ADDENDUM NO. 2

DATE: January 19, 2010

PROJECT: THE TIE CENTER, AN INDIANA SCIENCE PARK
SCOTTSBURG, INDIANA 47170

PROJECT NUMBER: 07072.000

E3
A-323

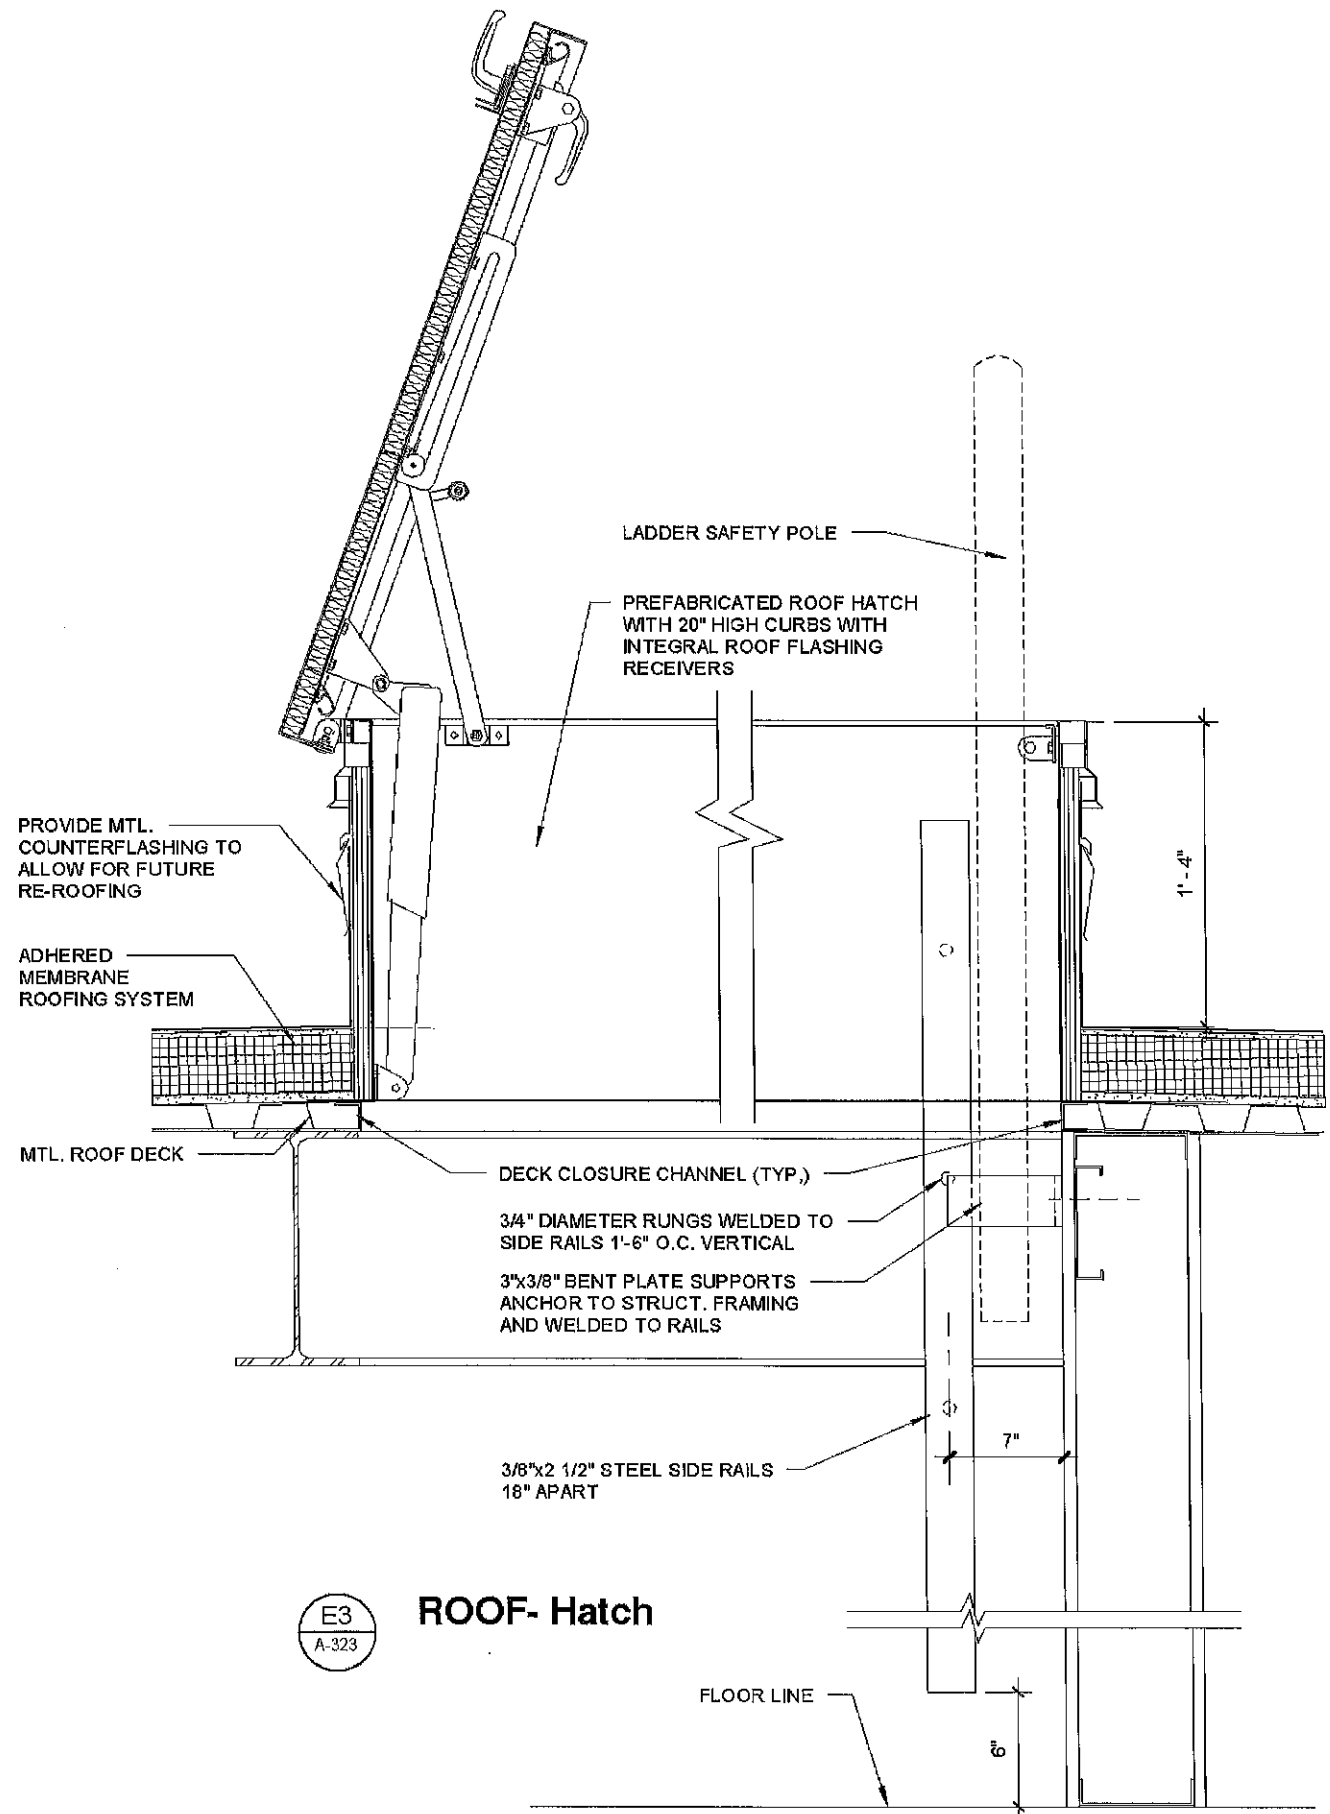
- 6. A-323 WALL SECTIONS
 - a. Add new Details D6/A-323 and E3/A-323 for roof hatch unit and ladder, as indicated on Sheet AD02-101A included with this addendum.

9
A-503

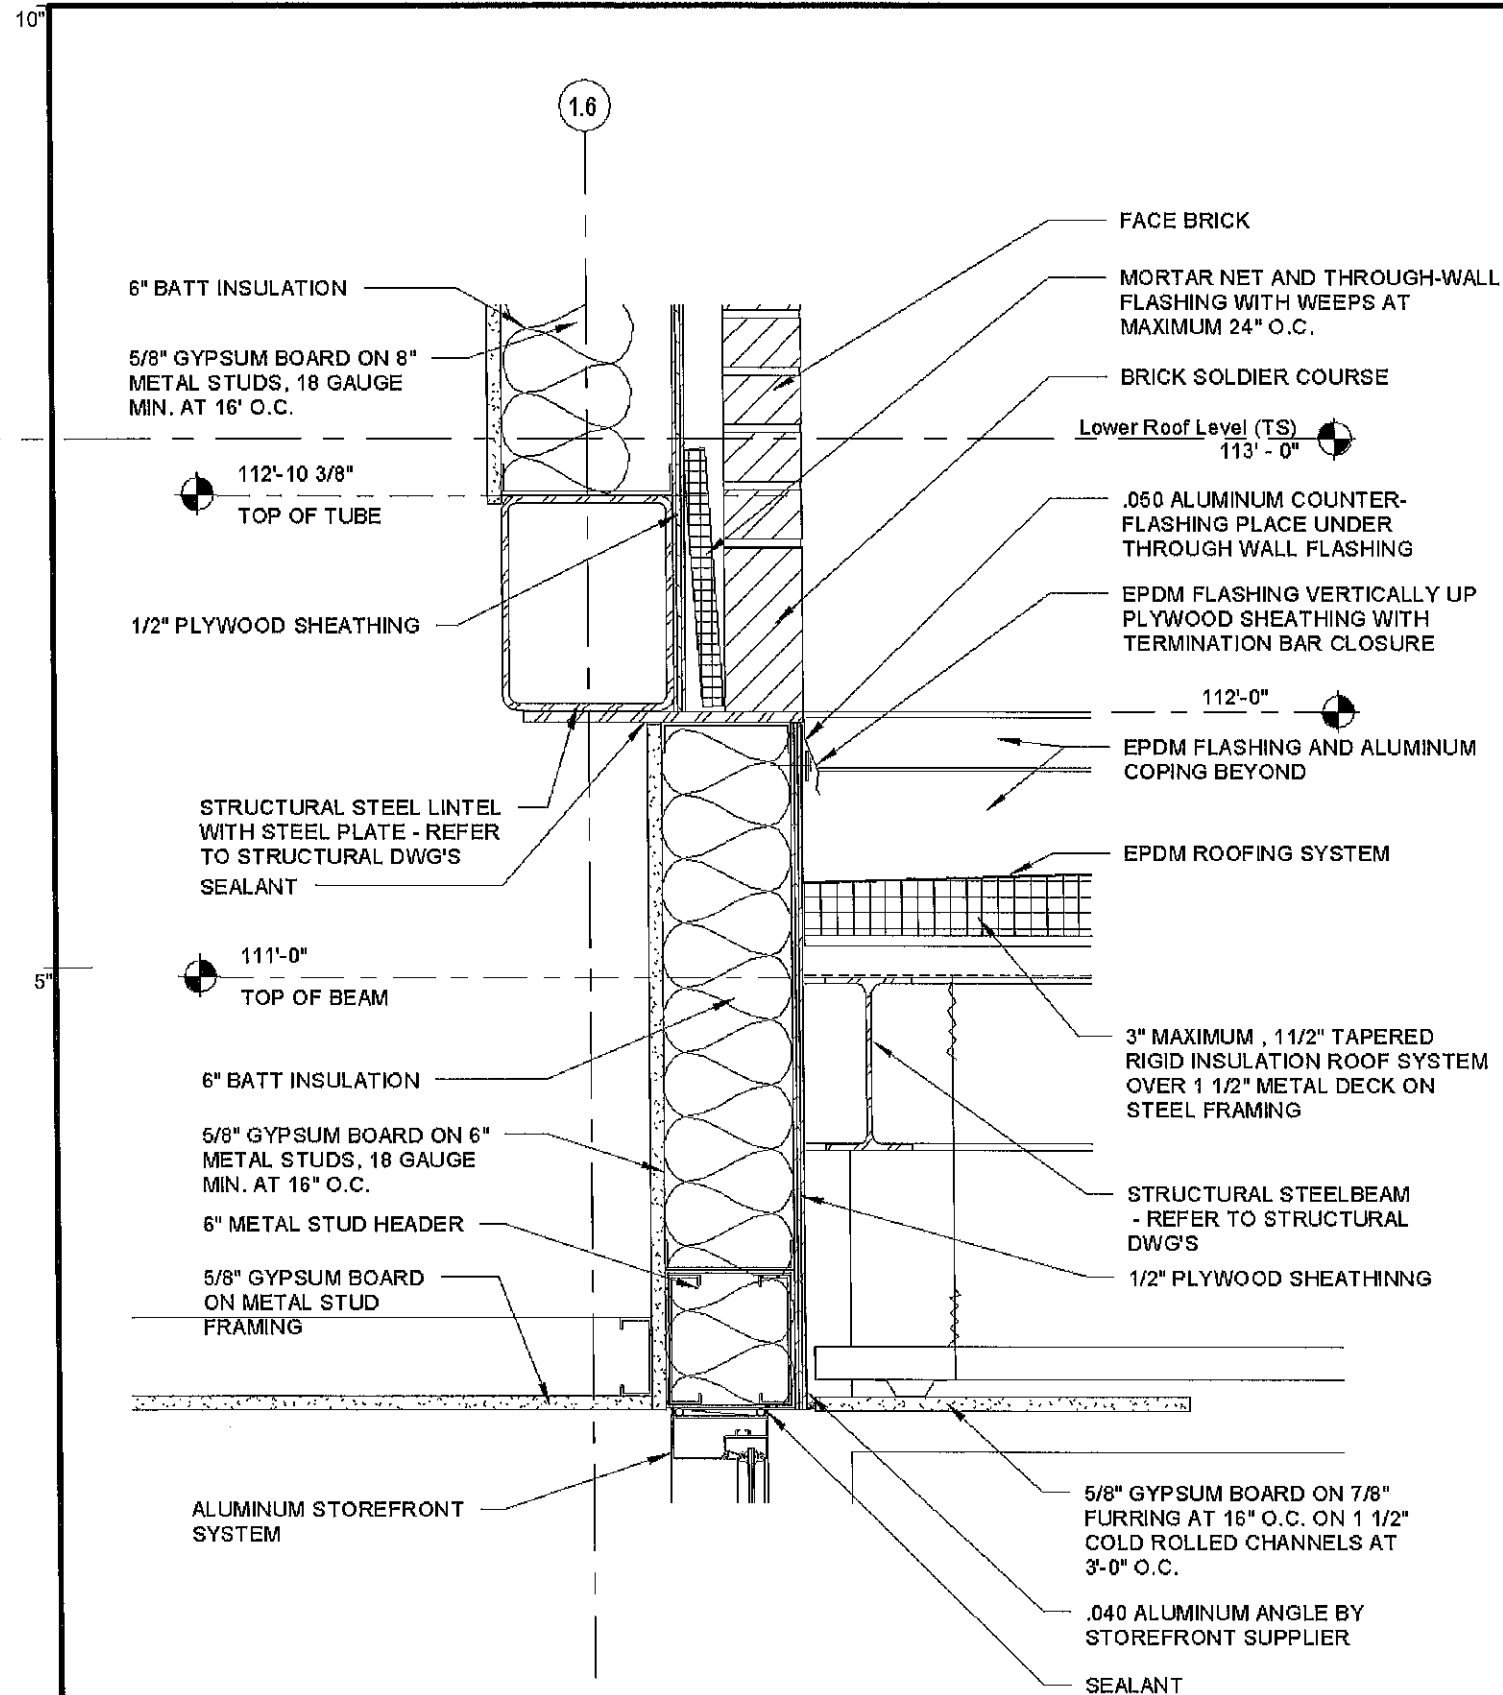
- 7. A-503 EXTERIOR DETAILS
 - a. Add new Details 8/A-503 and 9/A-503 for canopy details, as indicated on Sheet AD02-102A, included with this addendum.
 - b. Add new Detail 10/A-503 for extended parapet detail, as indicated on Sheet AD02-103A, included with this addendum.
